Applicant: Martin Schreier: TVC Properties
Consultant: Mike Kettler; Sunde Engineering
Project: Outside Dog Area – Camp Bow Wow
Location: 10100 Viking Drive; Suite 200: Eden Prairie
Rule(s): 4, 5,11 and 12
Reviewer: BCO

General Background & Comments

DESCRIPTION:
GRADING, DRAINAGE, AND EROSION CONTROL PLAN

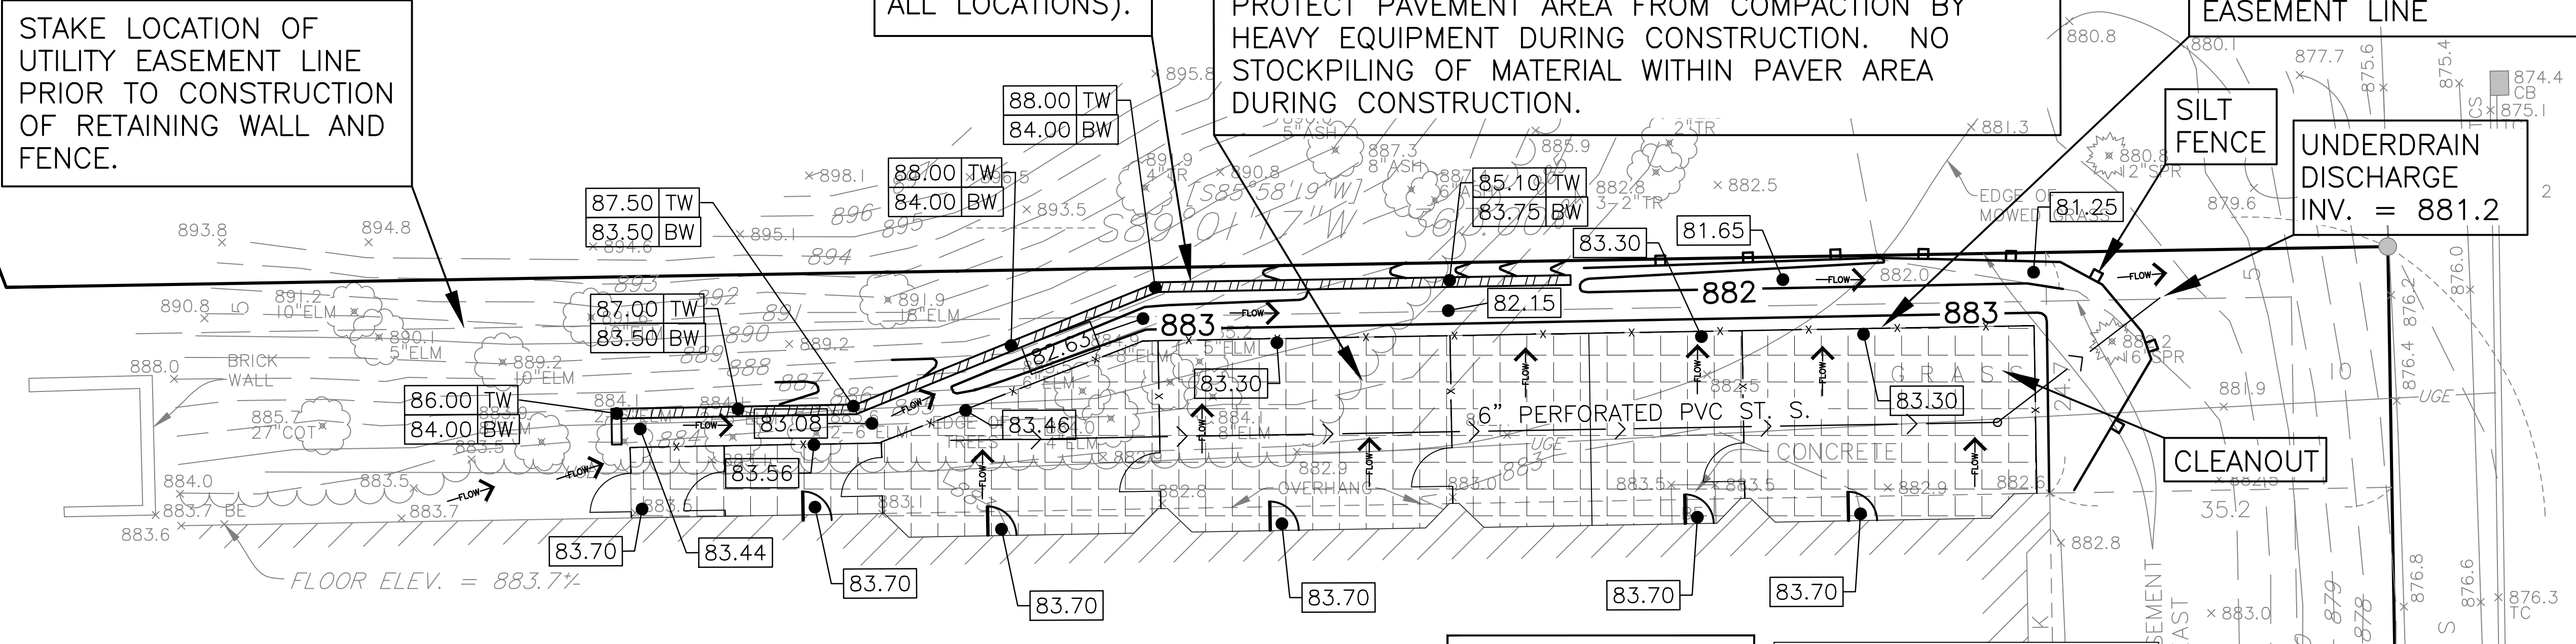
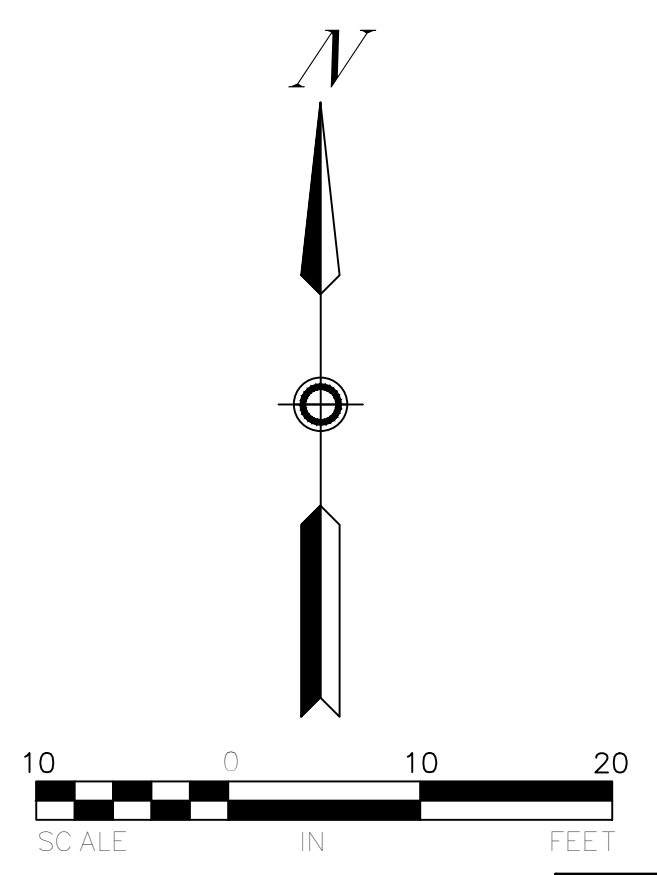
A volume retention of 216 cubic feet is required for 1.1-inches of runoff from the 2,354 square feet of site impervious area. The underground BMP will provide 314 cubic feet of volume retention assuming a 40% void ratio in the foundation material. The geotechnical report identifies the on-site underlying soils as silty clay loam (CL) having an infiltration rate of 0.2 inches/hour based on the Minnesota Stormwater Manual. Using this infiltration rate, an area of 270 square feet at a maximum depth of 0.8 feet is required for the 206 cubic feet of volume retention to be drawn down within 48 hours. An area of 2,354 square feet, the entire footprint of the paver area, is to be provided. Rule 4.3.1a is met.

District Rule 4.3.3c states that all new and reconstructed buildings must be constructed such that the low floor elevation is at least two feet above the 100-year high water elevation or one foot above the emergency overflow of a constructed facility. In addition, all new and reconstructed buildings must be constructed such that no opening where surface flow can enter the structure is less than two feet above the 100-year high water elevation of an adjacent facility or waterbody. The finished floor and low opening elevation of the existing building is 883.7 M.S.L. The calculated 100-year frequency high water elevation of the BMP is 881.6 M.S.L. – a separation of 2.1 feet. The requirements of Rule 4.3.3c are met.

The geotechnical report indicates that redoximorphic was encountered at elevation 873.3 M.S.L. The interface elevation of the BMP and the native soil is 881.2 M.S.L. providing a separation of 7.9 feet. A minimum separation of 3 feet will be provided between the bottom of the infiltration area and groundwater as required by Rule 4.5.4d (i).

The submitted erosion and sediment control plan includes silt fence at the limits of construction. The project contact is Diana Hall, Camp Bow Wow.
